Our reference: P-1052180-B1C0
Contact: Sandra Fagan
Telephone: (02) 4732 7992

Council Advice on the Environmental Impact Statement for 'STACK SYD01 Data Centre - SSD-82211208 - 78 Lockwood Road Data Centre, Erskine Park, NSW, 2759

Image of 1% AEP Flood Extent

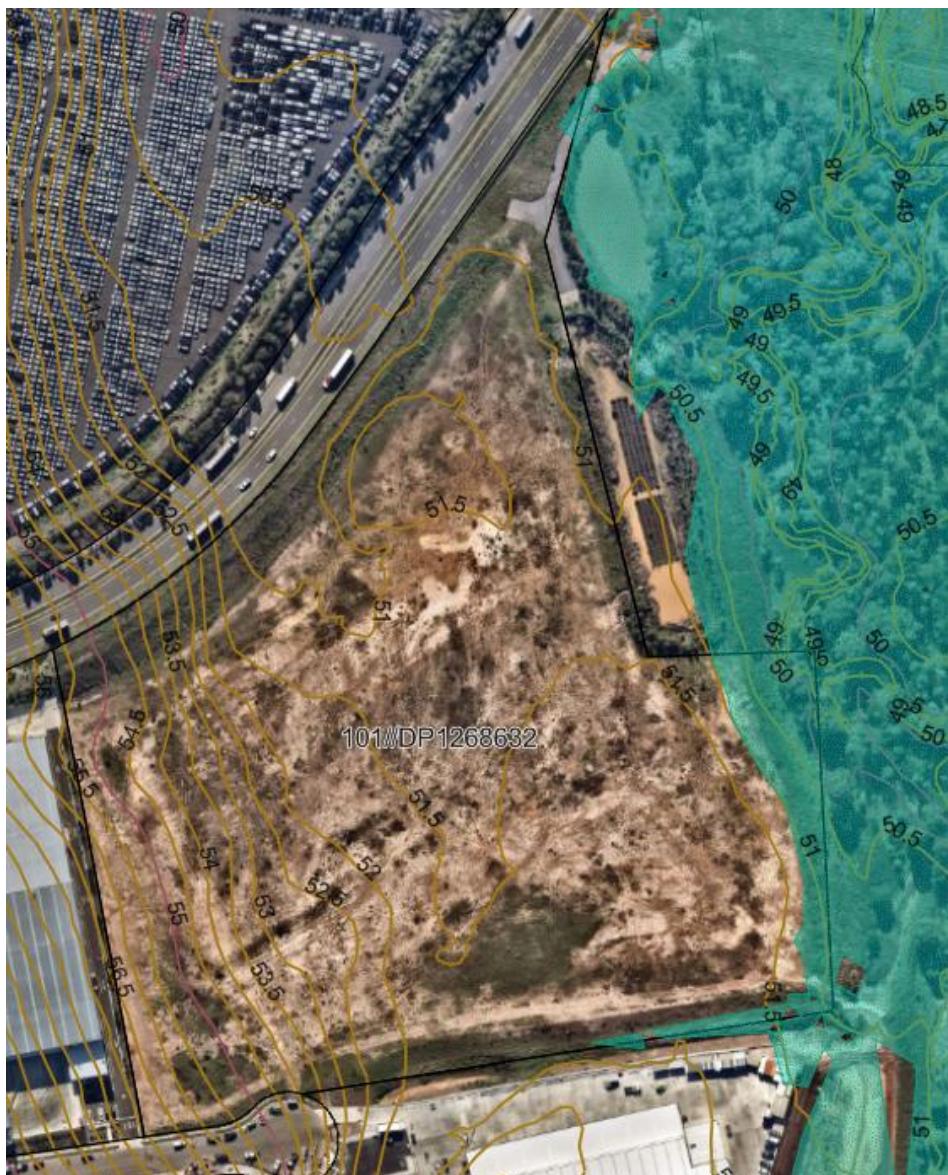
- a) The site is flood affected by local overland flow flooding from the local catchment. An extract of the local overland flood flows through the western portion of the site is attached. There is an access road proposed around the eastern side of the generator gantry area that is within the 1%AEP flood affected area of the site. There will be associated retaining walls, footing and/or associated batters associated with any works in this area that are not clearly indicated. It is recommended the generator gantry area and associated service roads and the full extent of any battering or retaining structures required be designed clear of the 1% AEP flood extent.

- b) It is recommended the DPHI does not support any works or any filling within any portion of the site affected by the 1% AEP.
- c) An application can be made to Council to obtain Council's current adopted flood extent for the site. A Flood Level Enquiry request is to be made to Council via the Flood Level Information application
